NOT USED

03 POWER CURB DETAIL
SCALE: 3" = 1'-0"

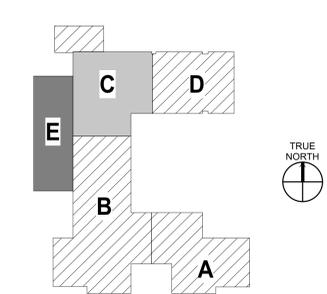
revision no:	issue date:
ADDENDUM #1	10/21/20
PR 01	03/01/21
PR 02	03/08/21
